**CITY OF BALTIMORE
DEPARTMENT OF GENERAL SERVICES
CAPITAL PROJECTS DIVISION**

Addendum No. 2

**For: CONTRACT NO. PRJ000889
HARFORD SENIOR RENOVATIONS & ENVELOPE UPGRADES**

SHEET
POO1

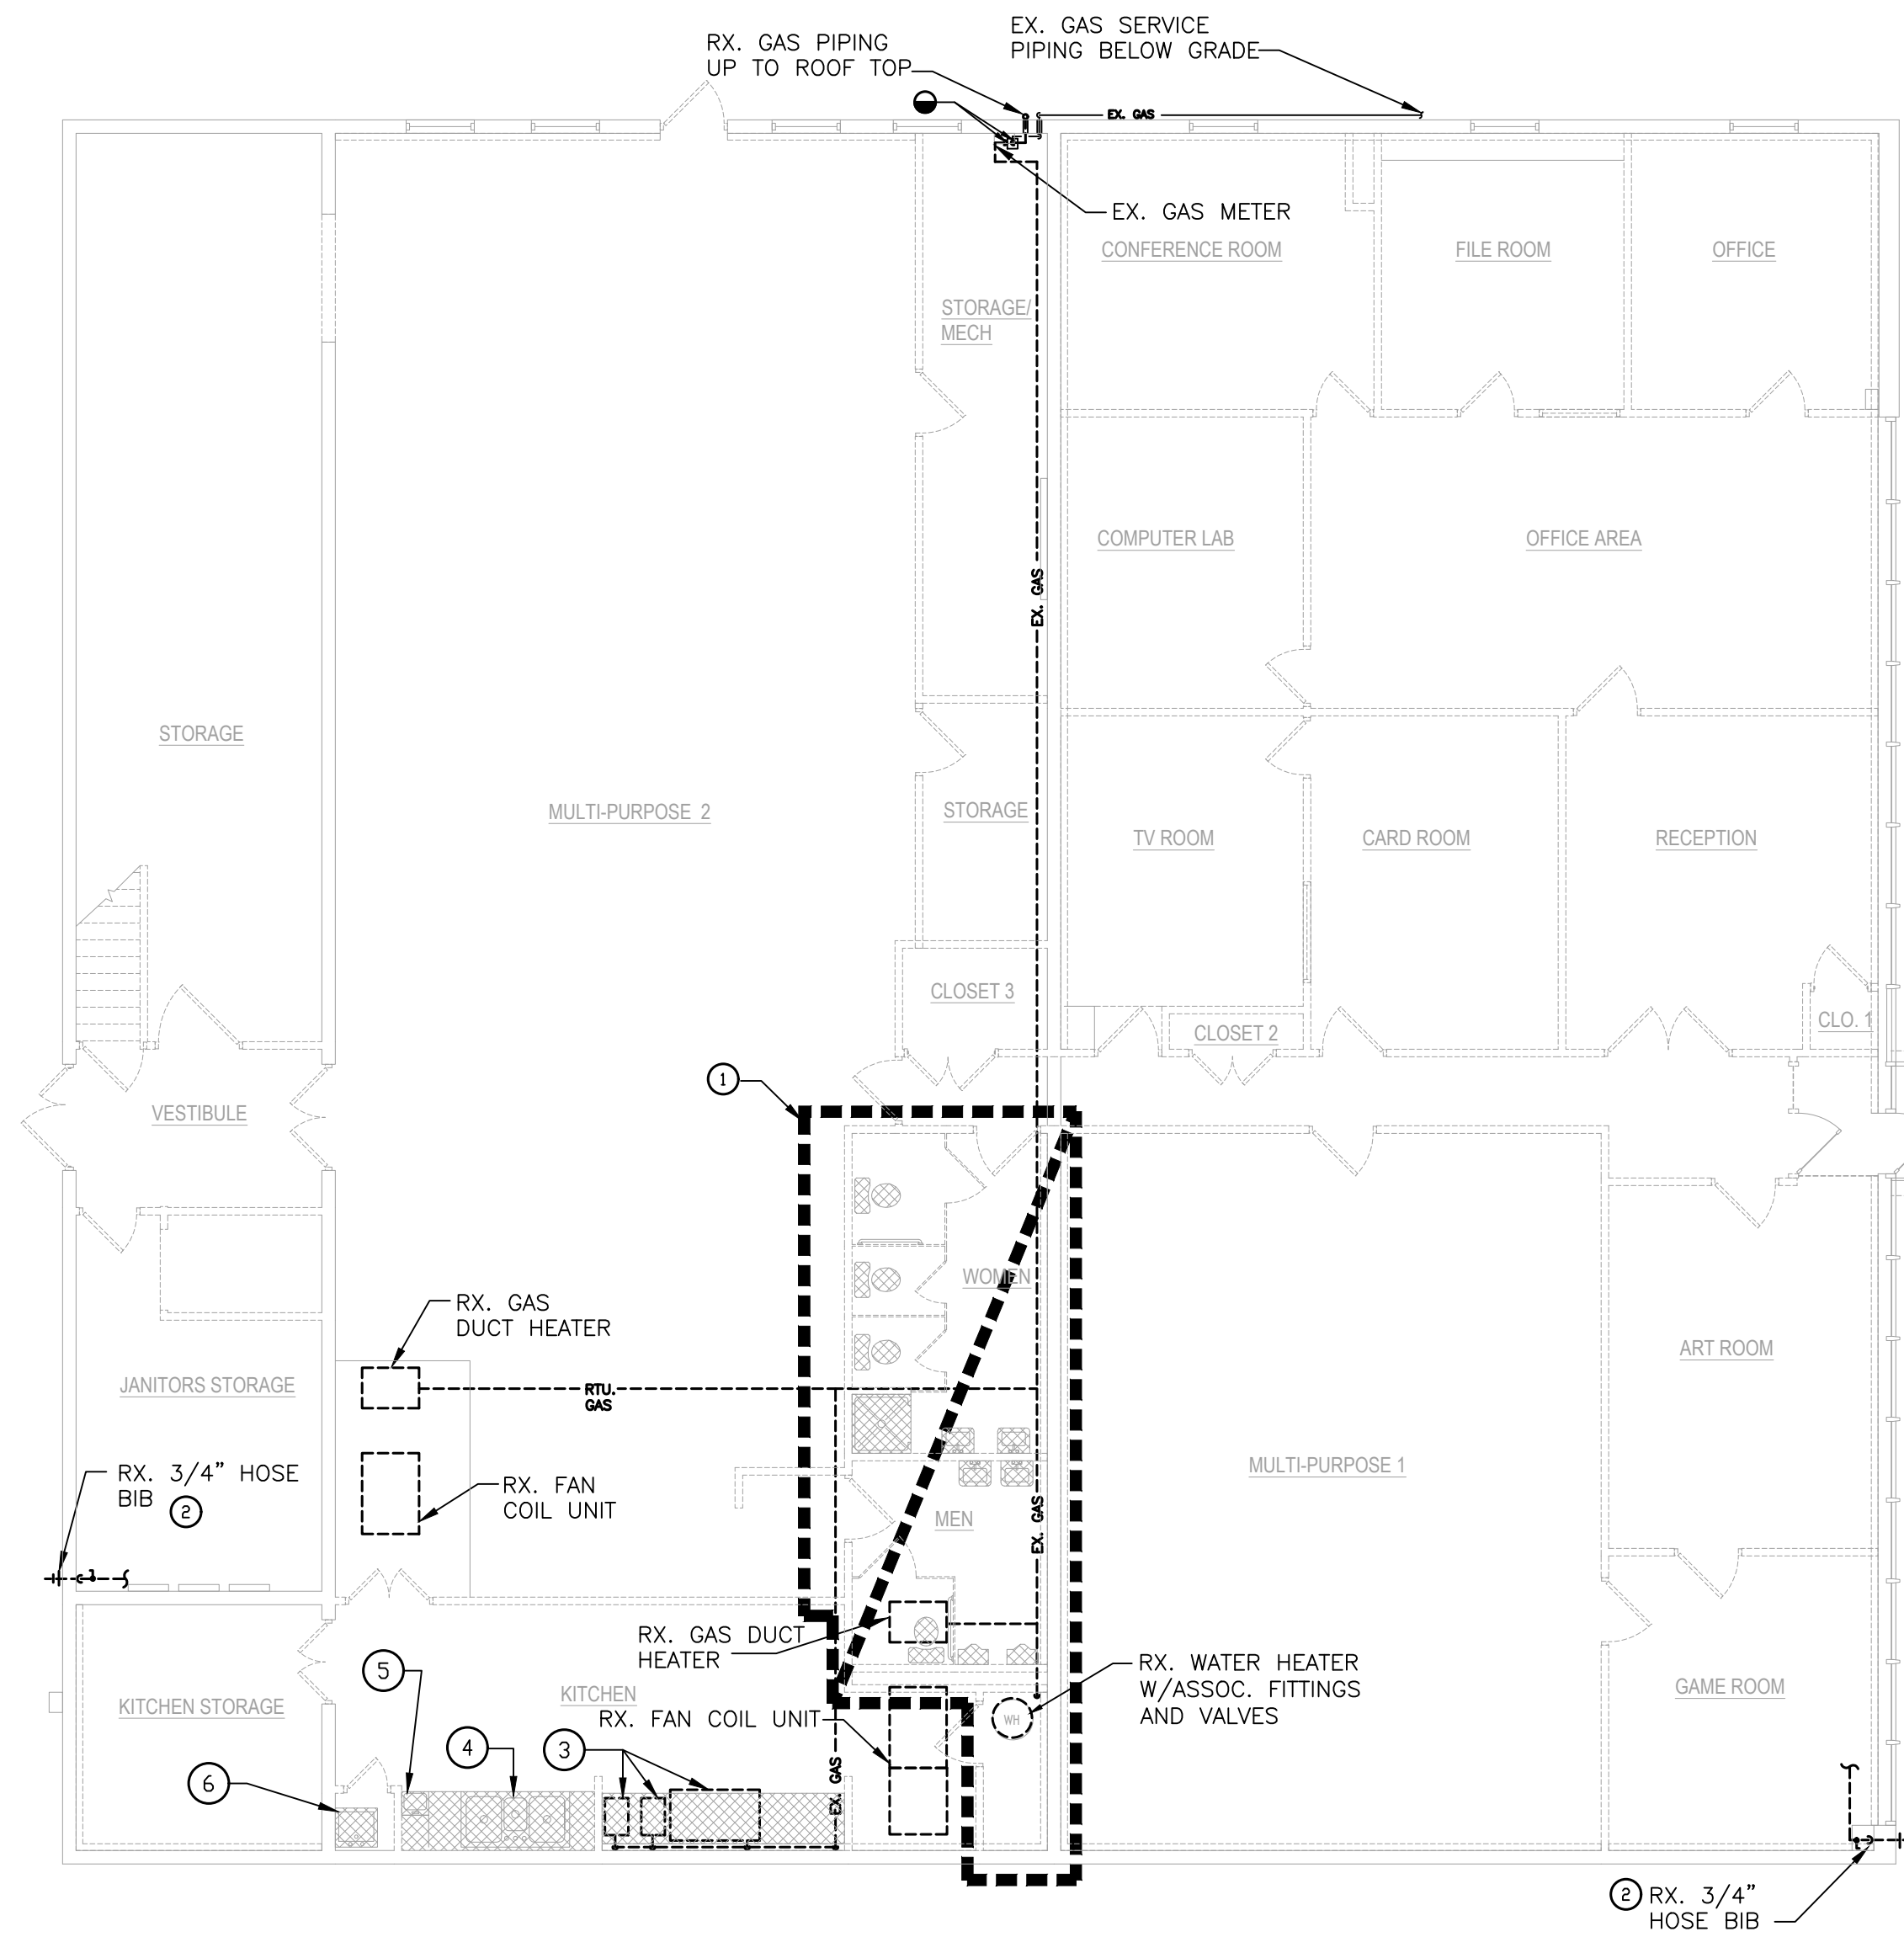
51. (Q): Specs lists CPVC as an option for aboveground domestic water pipe, drawing P001 does not. Which is correct? I know specs usually supersede drawings I'm just confirming
(A): **Please see revised drawing P001 which lists CPVC piping as an acceptable material for above ground domestic water piping, except for plenum areas.**

52. (Q): Specs lists PVC pipe as an option for aboveground sanitary / vent pipe, drawing P001 does not. Which is correct? I know specs usually supersede drawings I'm just confirming
(A): **Please see revised drawing P001 which lists PVC piping as an acceptable material for above ground drainage piping, except for plenum areas.**

6. Drawing P001 "Plumbing Schedules"
REMOVE: Drawing P001 in its entirety
INSERT: Revised Drawing P001 in its entirety
NOTE: Updated water supply pipe sizing for water closets and added additional information regarding acceptable materials for above ground water and drainage piping.

SHEET
PD 100

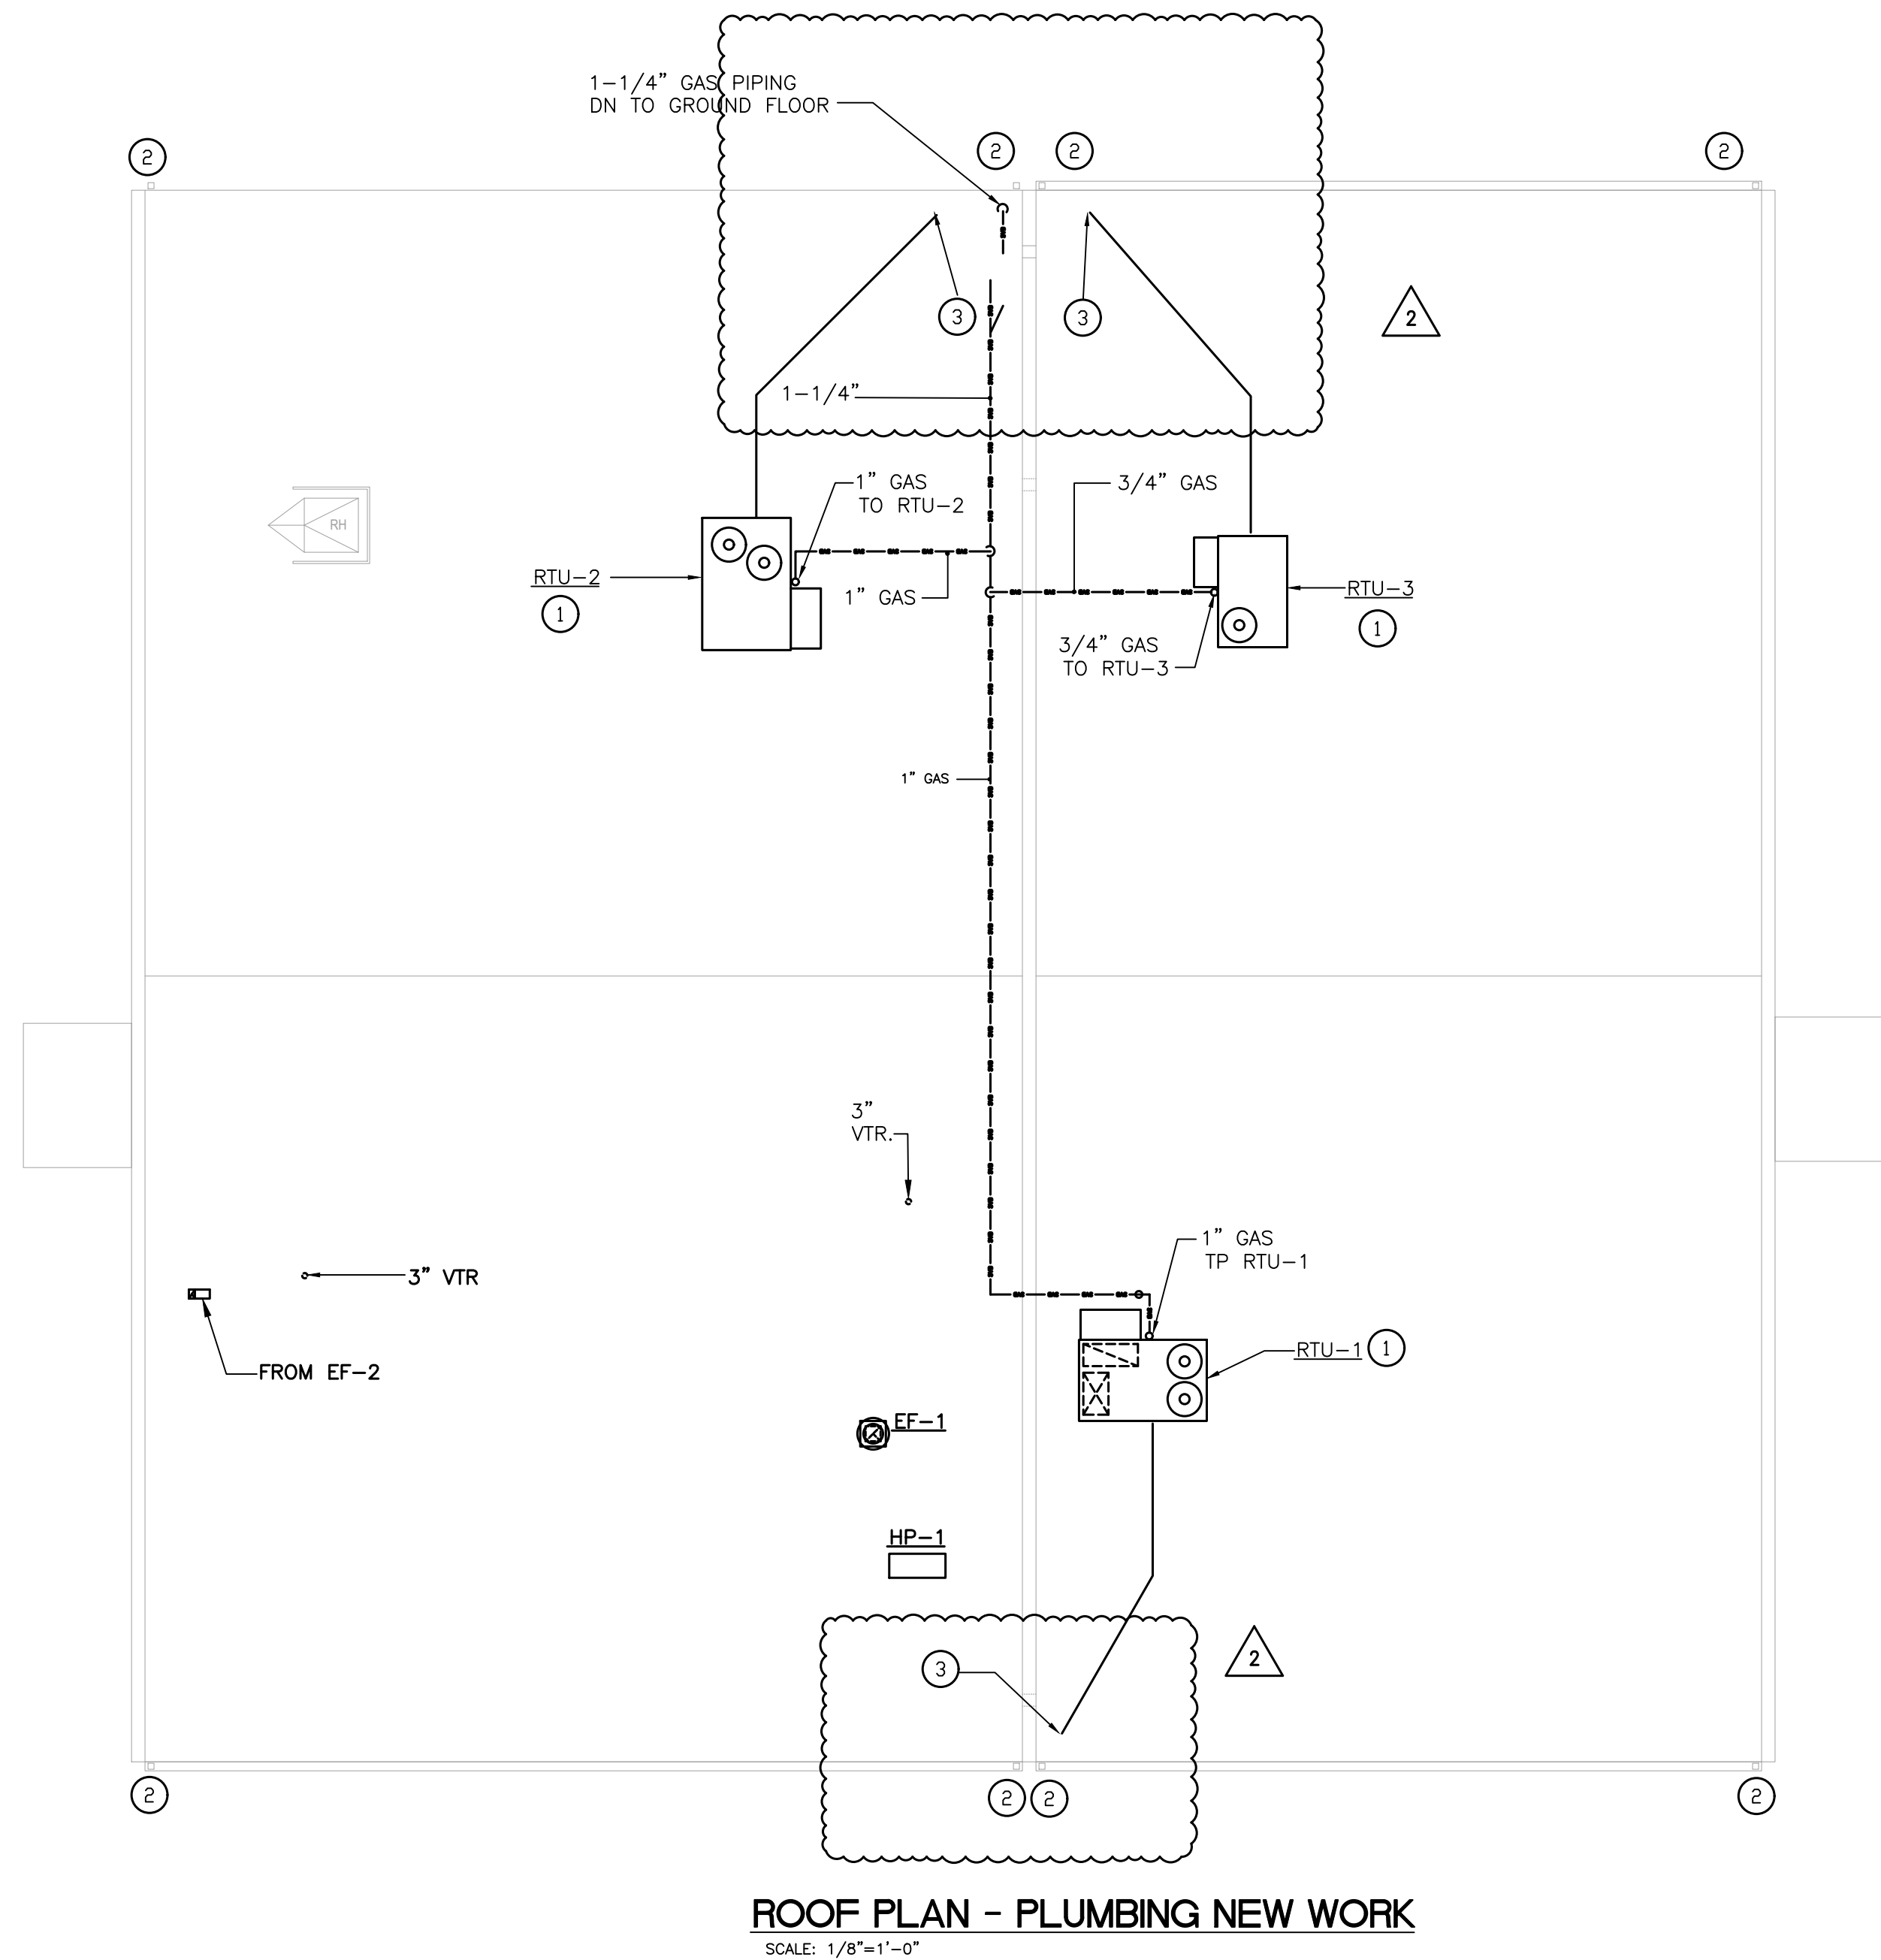
55. (Q): Is the existing grease interceptor that is getting demoed underground or aboveground?
(A): **Please see revised drawing PD-100 which notes the existing grease interceptor is above ground.**

7. Drawing PD100 "Plumbing Floor Plan Demolition"
REMOVE: Drawing PD100 in its entirety
INSERT: Revised Drawing PD100 in its entirety
NOTE: Updated demolition note #4.

SHEET
P101

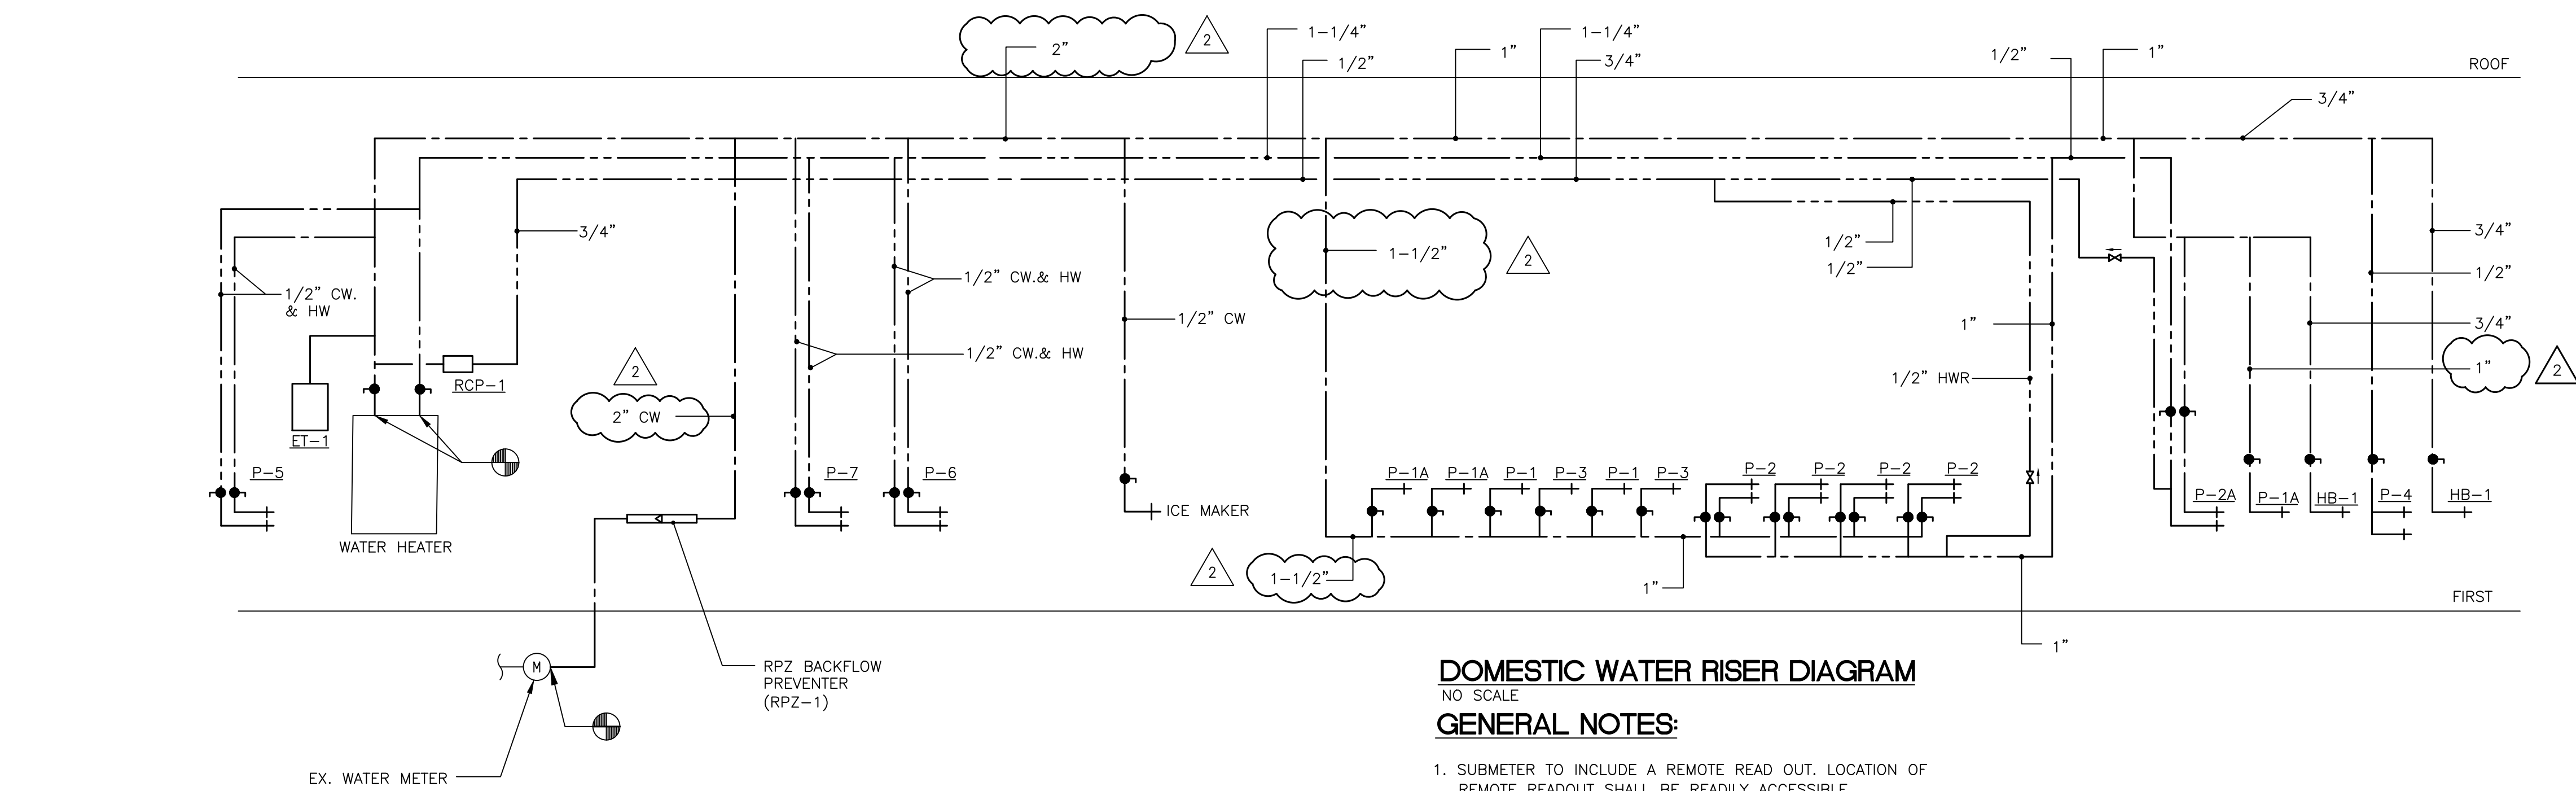
45. (Q): Sheet P101 showing 3 new RTU units on the roof, and new gas piping feeding these units. I believe Maryland code requires exposed roof gas piping to be painted Safety Yellow. Please advise.
 (A): **Please see revised drawing P101 with notes added to address painting of the exposed gas piping for proper identification.**

56. (Q): Where are the condensate lines from the RTU's being piped to? Are they being piped completely to the gutters? (None shown on drawings)
(A): **Please see revised drawing P101 with condensate drain piping added to the roof plan.**

8. Drawing P101 "Plumbing Roof Plan New Work"
REMOVE: Drawing P101 in its entirety
INSERT: Revised Drawing P101 in its entirety
NOTE: Notes added to address painting of the exposed gas piping. Notes added to address condensate drainage.

- A. REFER TO DATA SHEET FOR PLUMBING SYMBOLS AND ABBREVIATIONS.
- B. REFER TO PLUMBING RISER DIAGRAMS FOR ADDITIONAL SIZING OF UTILITIES AND PIPING.
- C. FOR PLUMBING FIXTURES AND EQUIPMENT, REFER TO PLUMBING SCHEDULE SHEET.
- D. DOMESTIC WATER PIPING IS LOCATED AT CEILING, UNLESS NOTED OTHERWISE.
- E. SANITARY PIPING IS LOCATED BELOW FINISHED FLOOR LEVEL, UNLESS NOTED OTHERWISE.
- F. VENT PIPING IS LOCATED HIGH AND TIGHT TO THE UNDERSIDE OF STRUCTURE, UNLESS NOTED OTHERWISE.
- G. EXPOSED GAS PIPING ON THE ROOF SHALL BE PAINTED YELLOW FOR CORRECT IDENTIFICATION.

- 1 EXTEND CONDENSATE FROM ROOFTOP UNIT TO DISCHARGE OVER CONCRETE SPLASHBLOCK.
- 2 NEW DOWNSPOUT CONNECTED TO EXISTING UNDERGROUND STORM WATER SYSTEM. REFER TO ARCHITECTURAL PLANS FOR ADDITIONAL INFORMATION.
- 3 RUN 1" CONDENSATE DRAIN TO NEAREST DOWNSPOUT.
